NACELLE - EXHAUST - EXHAUST CONE INSTALLATION BOLTS - REPLACEMENT OF - 6 -
MOD.NAC-78-0066

V2500-NAC-78-0066

International Aero Engines

Installation of Exhaust Nozzle
Fig.1

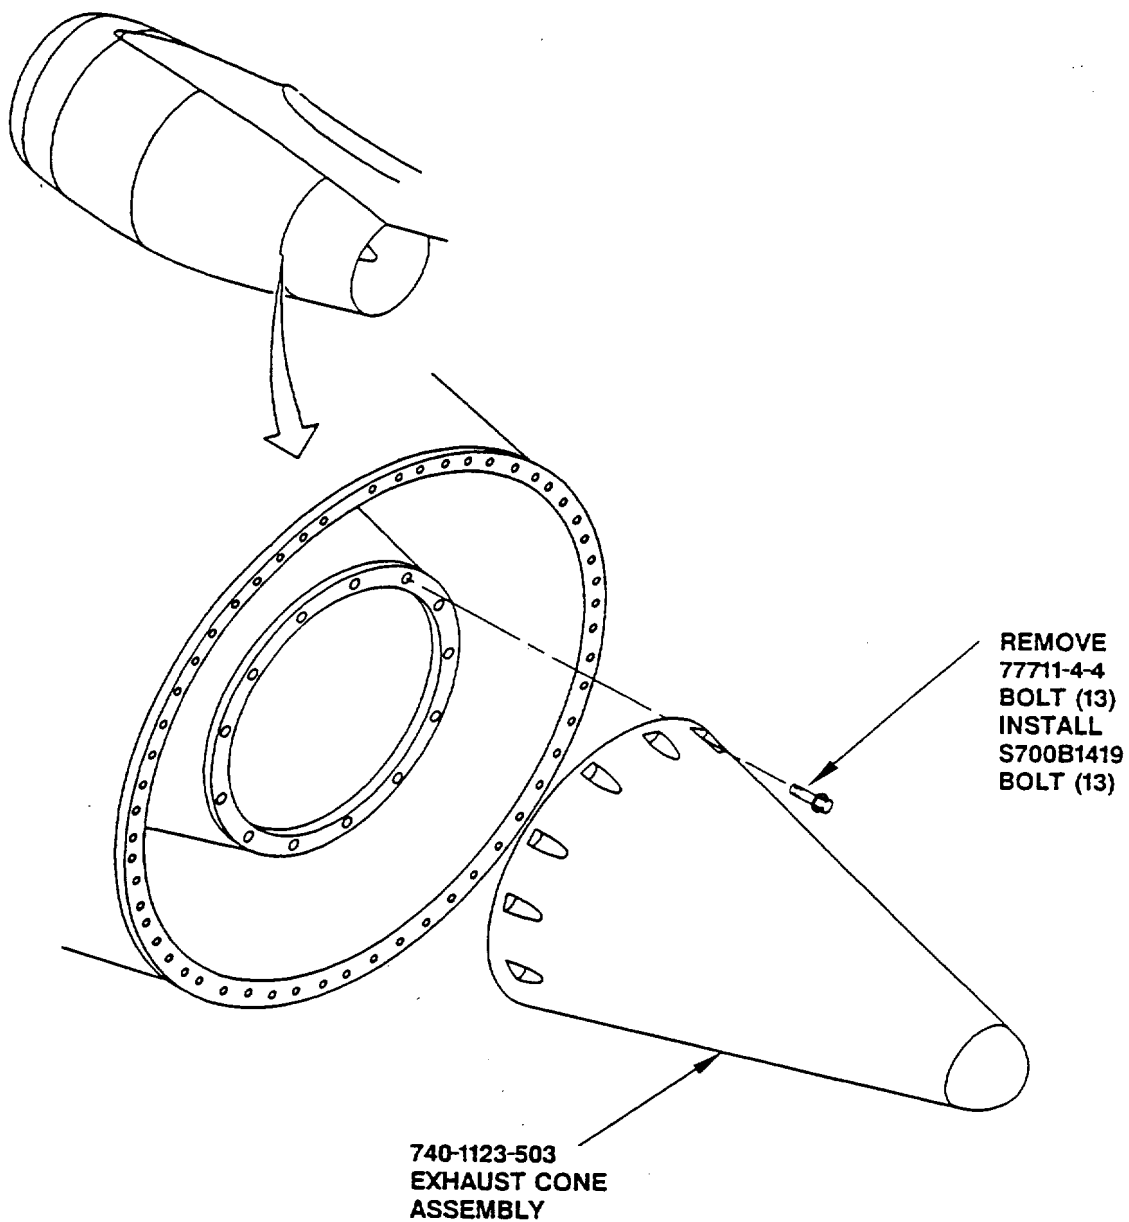
Existing exhaust cone attach bolts may have inadequate grip length.

Operators have reported loose bolts.

- (a) Existing cone attach bolts are replaced with new longer bolts provided in this Service Bulletin Kit.

- (1) Remove the Exhaust Cone as specified in the A320 Aircraft Maintenance Manual, Task 78-11-12-000-010. Refer to Figure 1.
- (2) Discard (13) 77711-4-4 bolts.
- (3) Install Exhaust Cone with (13) S700B1419 bolts as specified in the A320 Aircraft Maintenance Manual, Task 78-11-12-400-010.
